ANN ARBOR HISTORIC DISTRICT COMMISSION

Staff Report

ADDRESS: 1117 West Washington Street, Application Number HDC15-060

APPLICATION: The applicant seeks HDC approval to remove several concrete walks, replace some of them with brick pavers, install a new brick paver walk, install a wood landing, install a large patio in the side yard, and install a radon abatement system.

Scale: 1/16" = 1'
 Landscape Plan: 1720
 Natoli Renovation

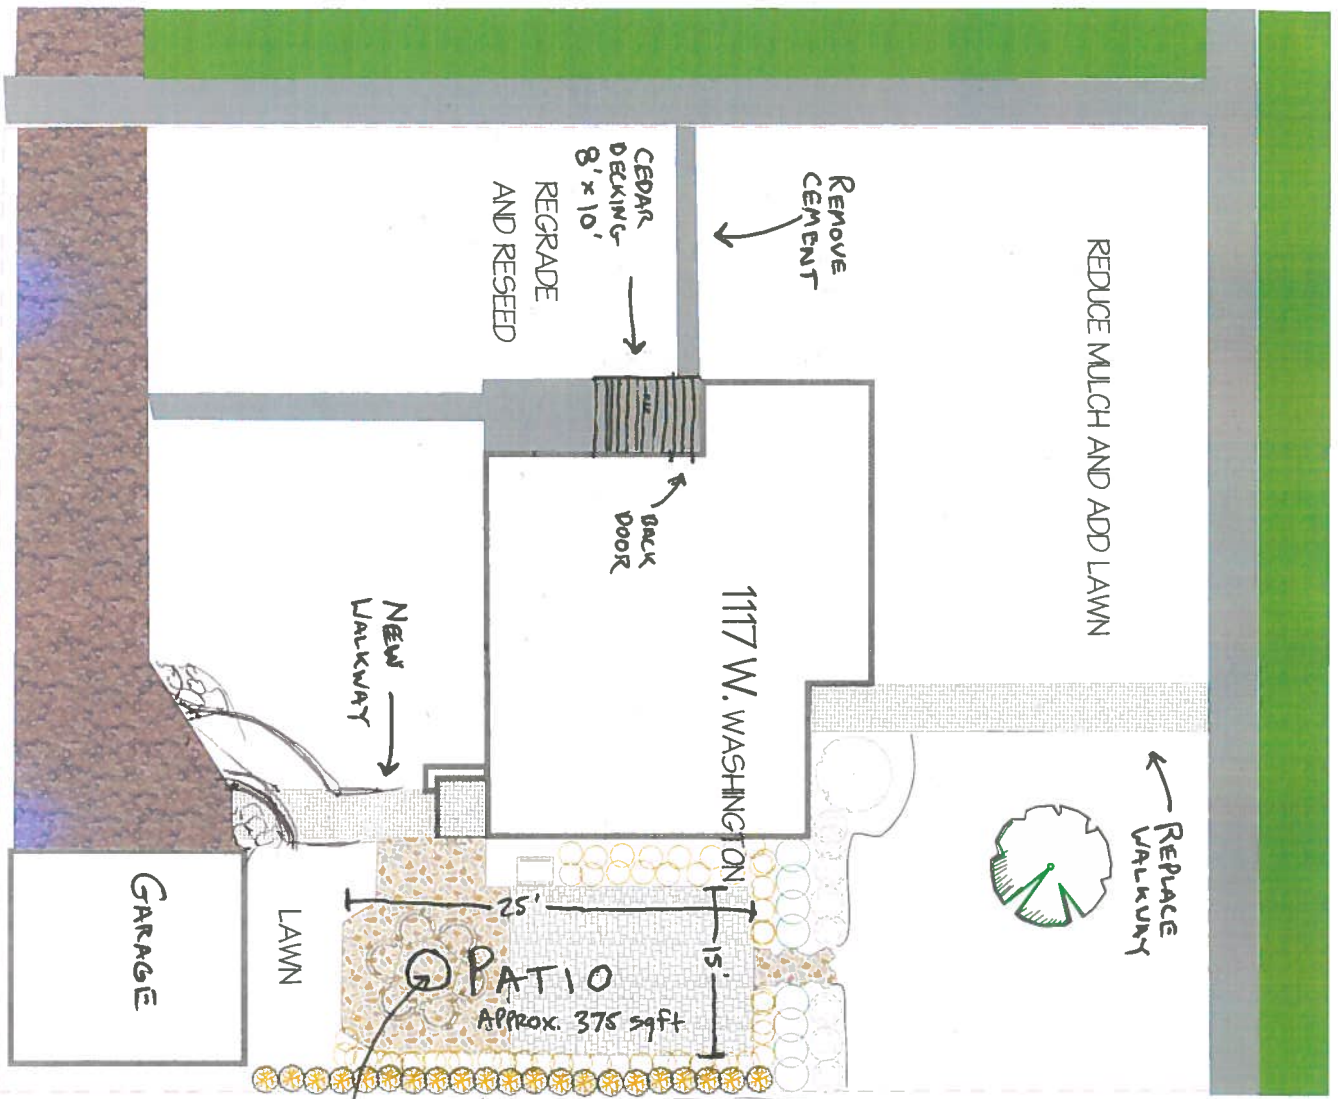
1. The house is on a corner lot, and thus has two fronts (on West Washington and Buena Vista). The large proposed patio is on the east side, which is the least visible part of the lot. The patio is 15' x 25' and uses large paver stones/tiles. The narrower end is toward the street. A representative photo is included in the application. The front walk is proposed to be replaced with brick pavers, and a new rear walk is proposed to be added of same.

2. On the west side of the house is an unused exterior door that the owners would like to remove the walkway to. The concrete landing outside the door has grading and drainage issues and is proposed to be replaced with a wood decking landing at grade. As long as a landing is retained, staff does not oppose the removal of the concrete walks leading to it since it is no longer used as a principal door. Similarly, adding a walkway to the back door is appropriate since that is now a heavily used entrance.
